Volvo Chassis - Technical Service Bulletin V-284 - 068, Exhaust Particulate Sensor, Repair (2016 Vehicles)

Exhaust Particulate Sensor, Repair

V-284-068

Volvo with a 2 Box exhaust after-treatment system (EATS) and built between January 1st, 2016 and February 3rd, 2020.

Repair 2

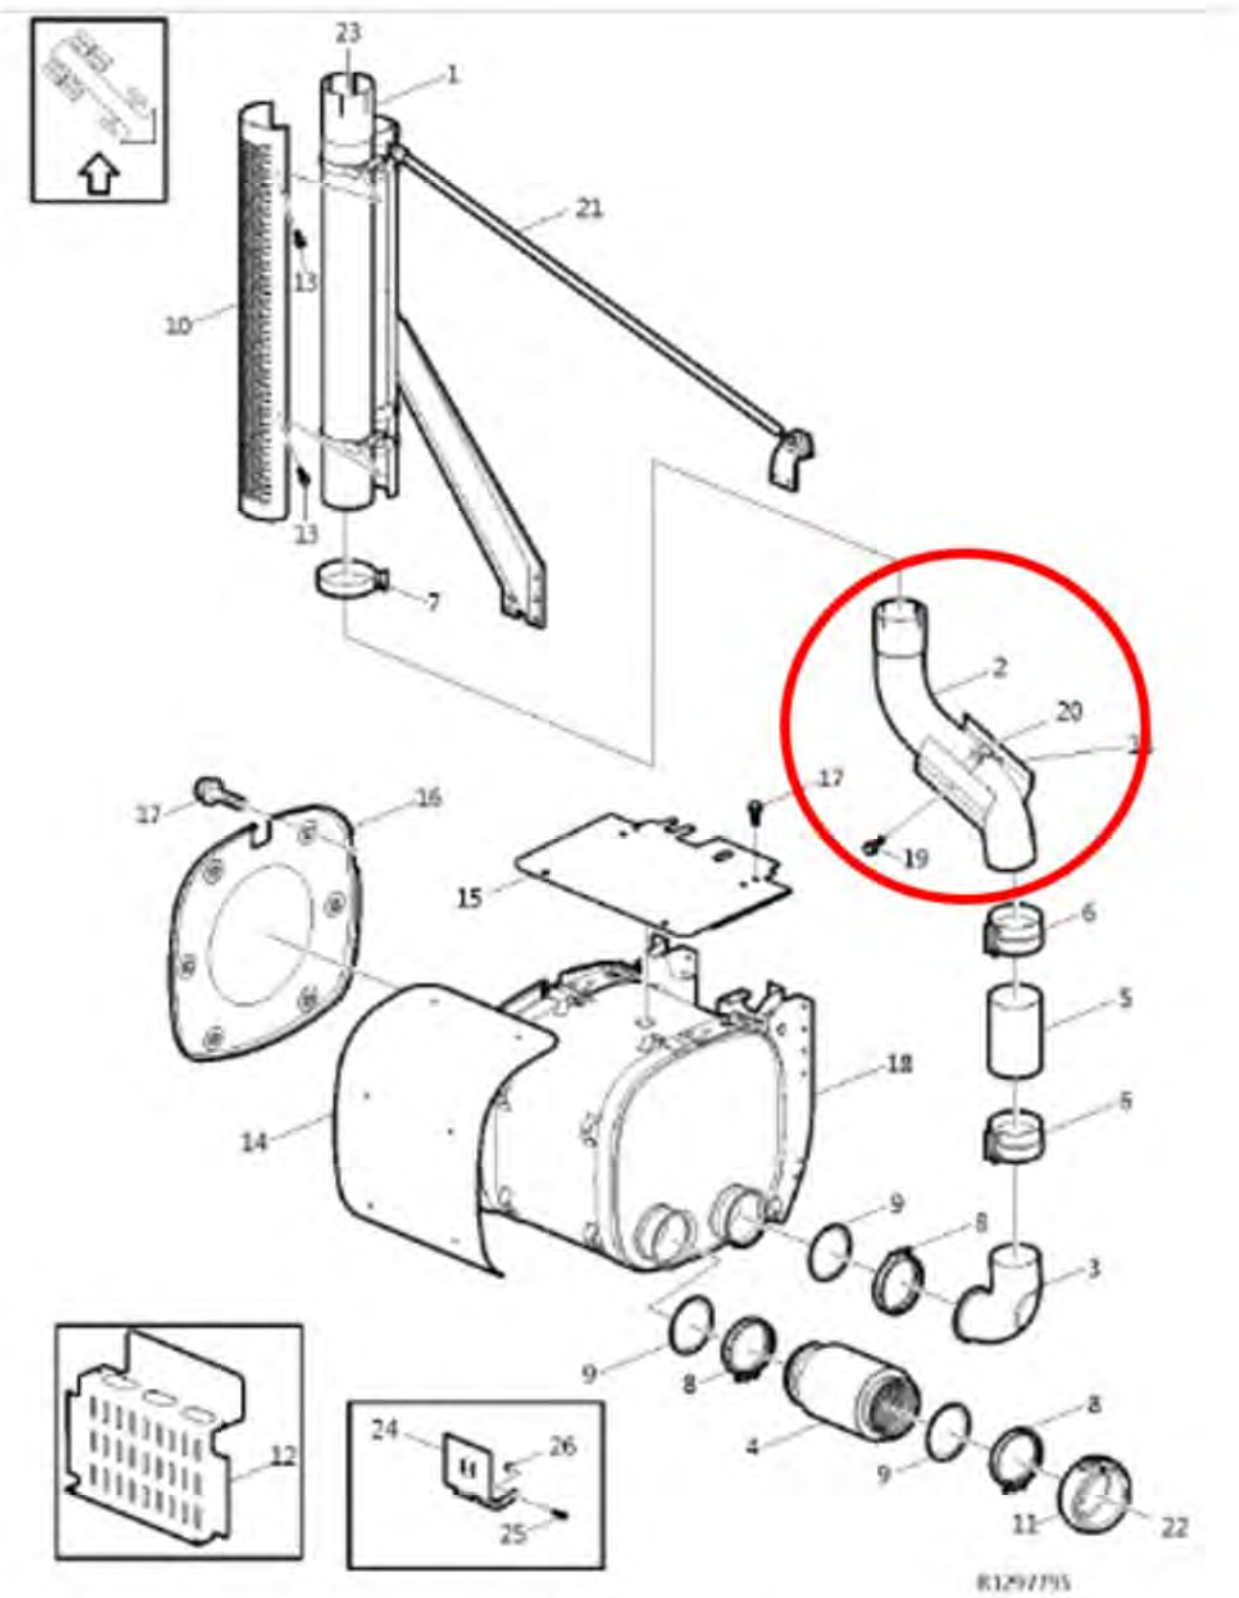
Model	Cab Type	Exhaust Configuration	Pipe 1
VNM/VHD	Day Cab	Single Outlet Right Side Inboard	23630037

Repair 3

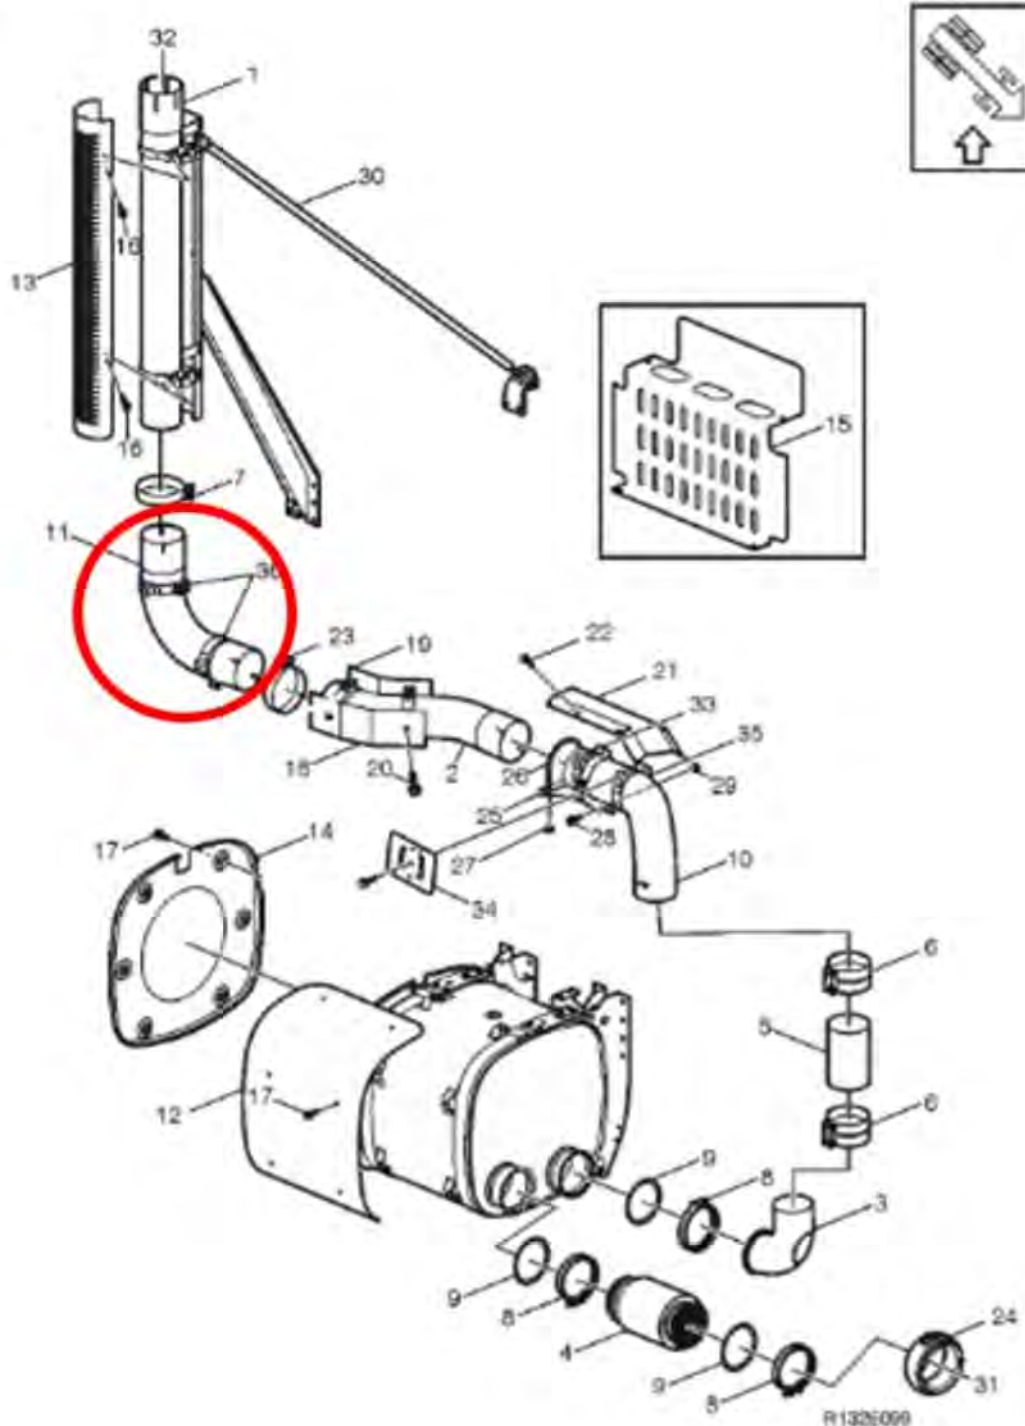
Model	Cab Type	Exhaust Configuration	Pipe 1
VNL/VHD	430/630 Sleeper	Single Outlet Right Side Inboard	(Not Bright) 23154798

Note: If the original flex pipe has previously been replaced, you will need a new elbow in addition to the new flex pipe.

Model	Cab Type	Exhaust Configuration	Elbow
VNL/VHD	430/630 Sleeper	Single Outlet Right Side Inboard	21687278

Repair 4

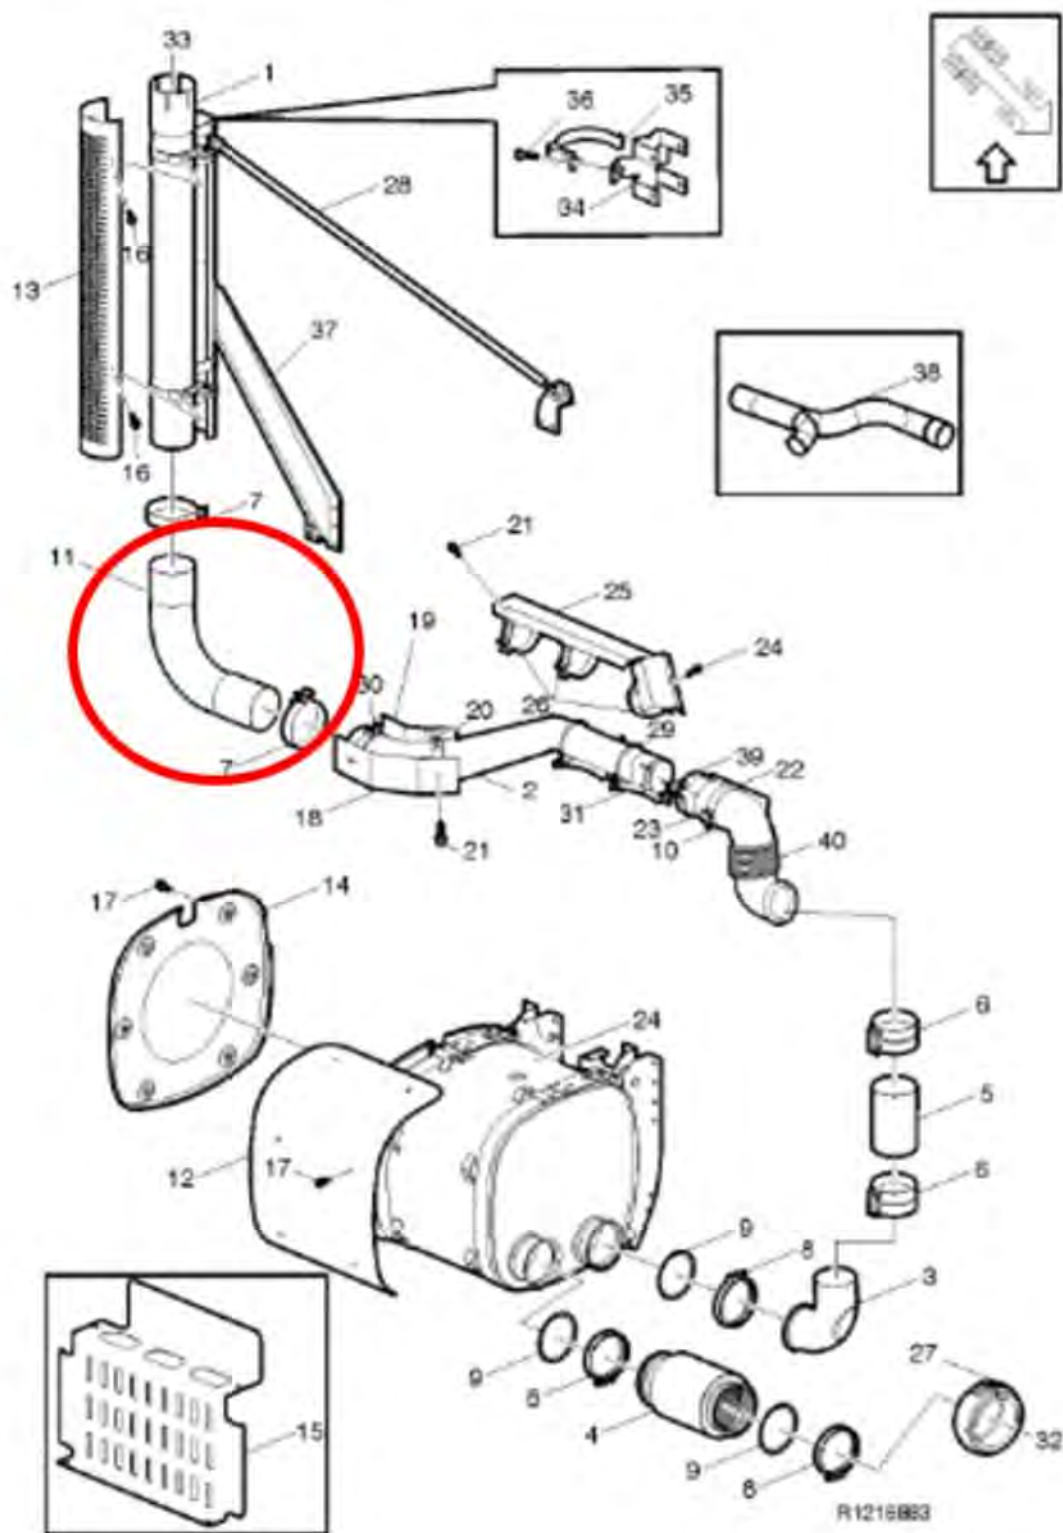
Model	Cab Type	Exhaust Configuration	Pipe 1
VNL	430/670/780 Sleeper	Single Outlet Right Side Inboard	(Not Bright) 23154798 (Bright) 23154799

Note: If the original flex pipe has previously been replaced, you will need a new elbow in addition to the new flex pipe

Model	Cab Type	Exhaust Configuration	Elbow
VNL	430 Sleeper	Single Outlet Right Side Inboard	21625282

Model	Cab Type	Exhaust Configuration	Elbow
VNL	670/780 Sleeper	Single Outlet Right Side Inboard	21625281

Repair 6

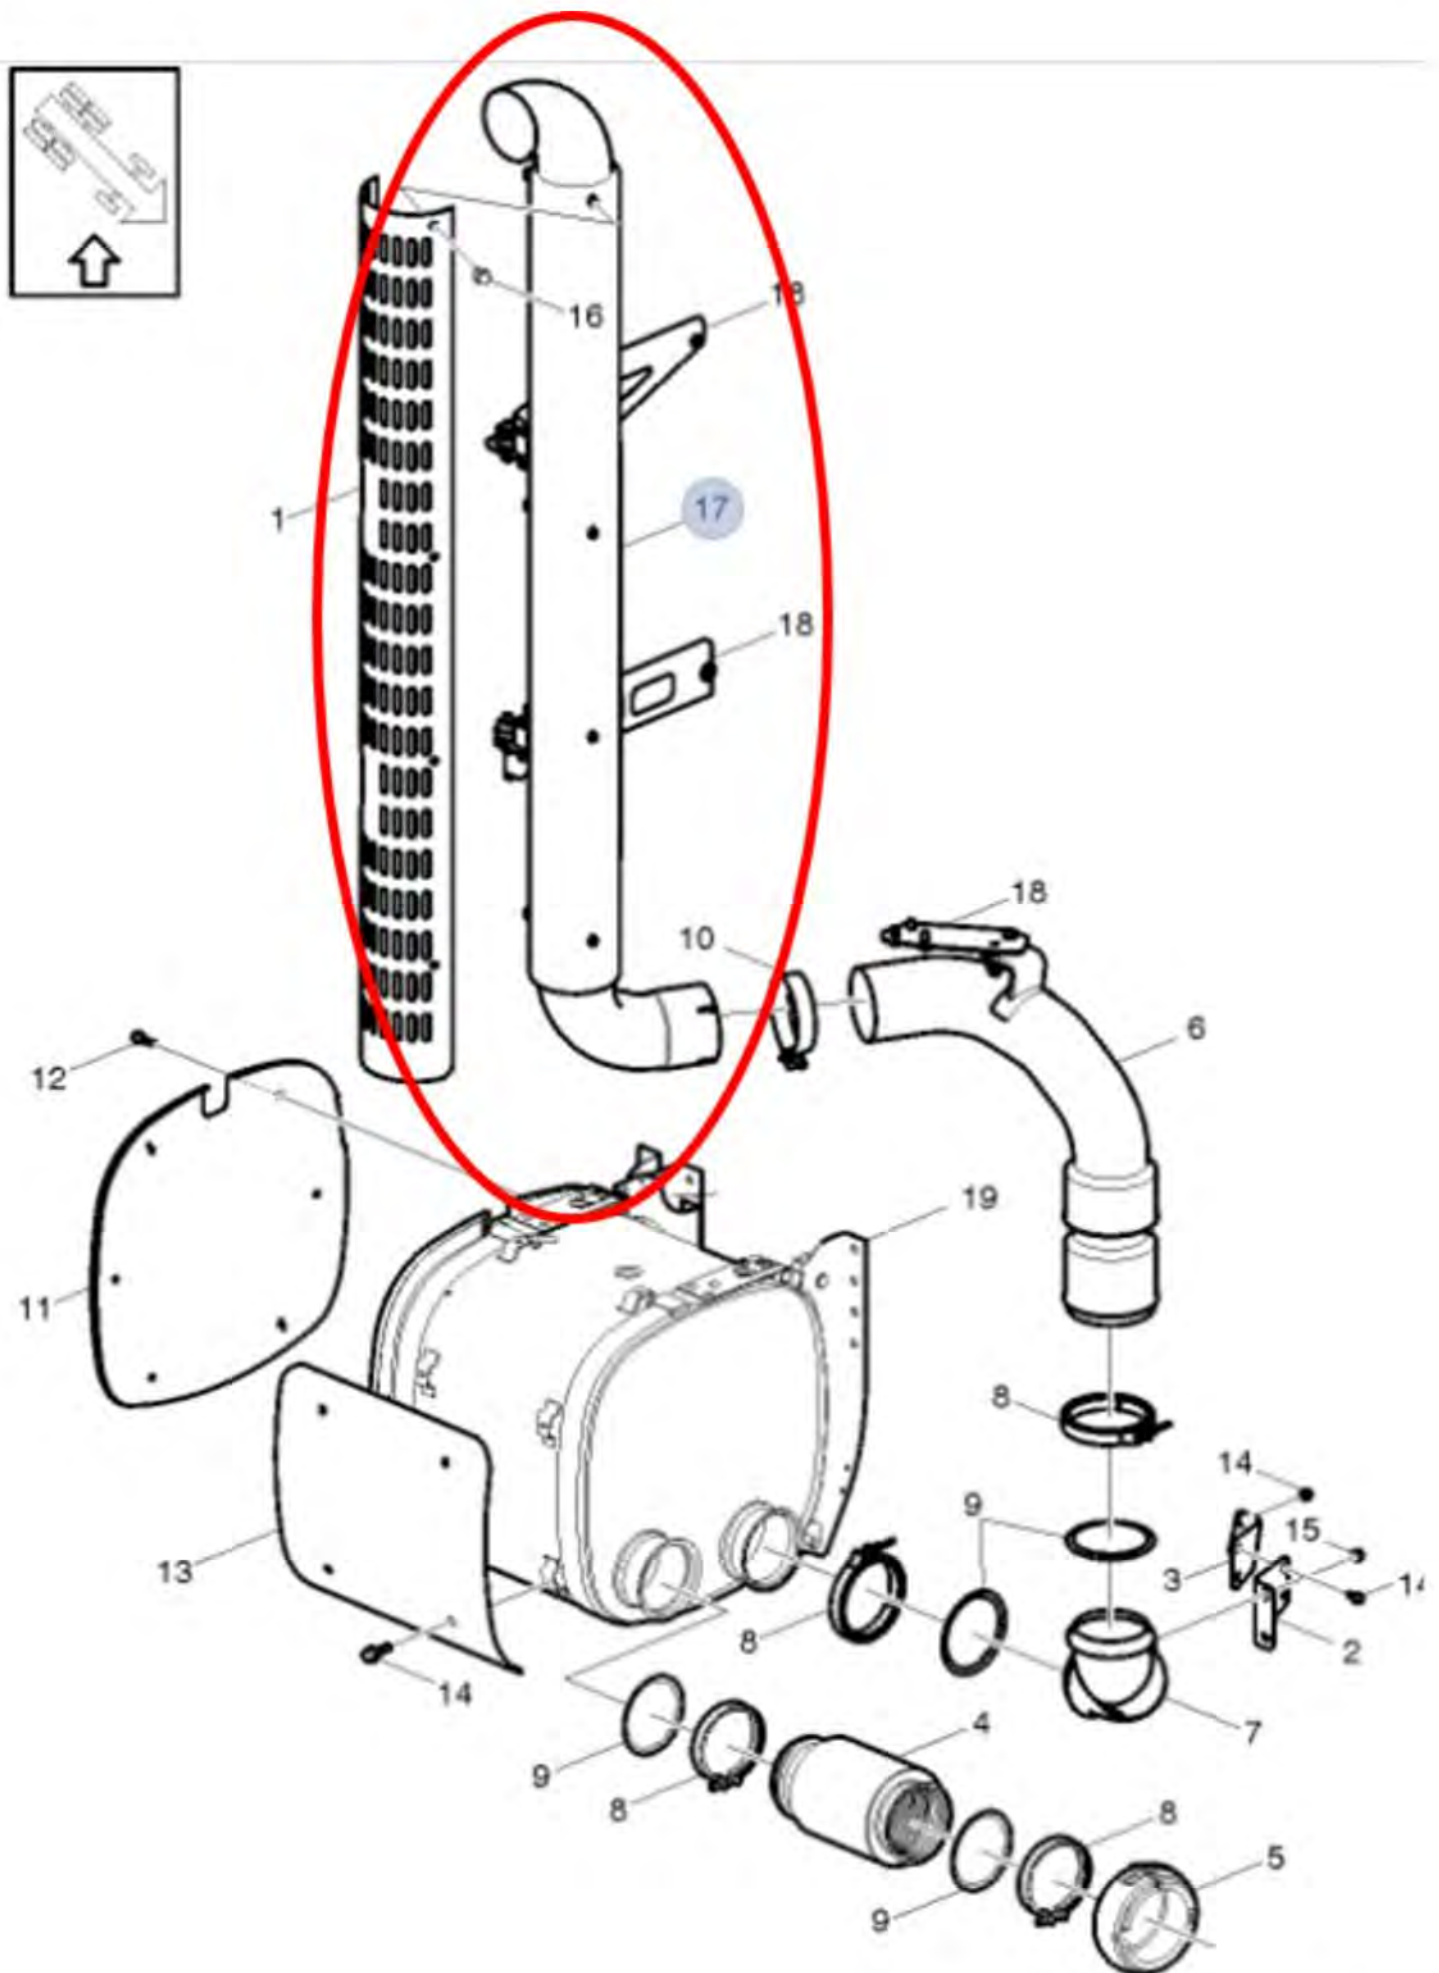
Model	Cab Type	Exhaust Configuration	Pipe 1	Clamp (Qty will vary)
VHD/VNM	Cab Mounted	SCR RH Horizontal Forward Mount	23154823	20961913
VHD/VNM	Cab Mounted	SCR Horizontal	23154825	20961913
VNL 11/13	Cab Mounted	SCR Horizontal	23154827	20961913

Repair 7

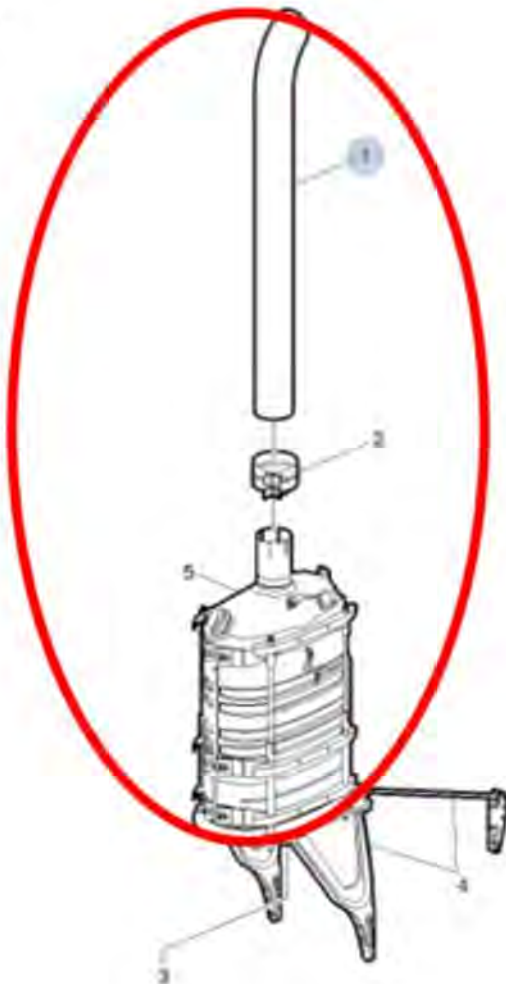
vary)
All	16L	12.5 ft Exhaust Stack Right Side	23208705	23296273	23189982
All	11L / 13L	11 ft 8 in Exhaust Stack Right Side	(Not Bright) 23208698 (Bright) 23208699	23176623	23189982
All	11L / 13L	12 ft 6 in Exhaust Stack Right Side	(Not Bright) 23208700 (Bright) 23208701	23176623	23189982
All	11L / 13L	13 ft 5 in Exhaust Stack Right Side	(Not Bright) 23208702 (Bright) 23208703	23176623	23189982
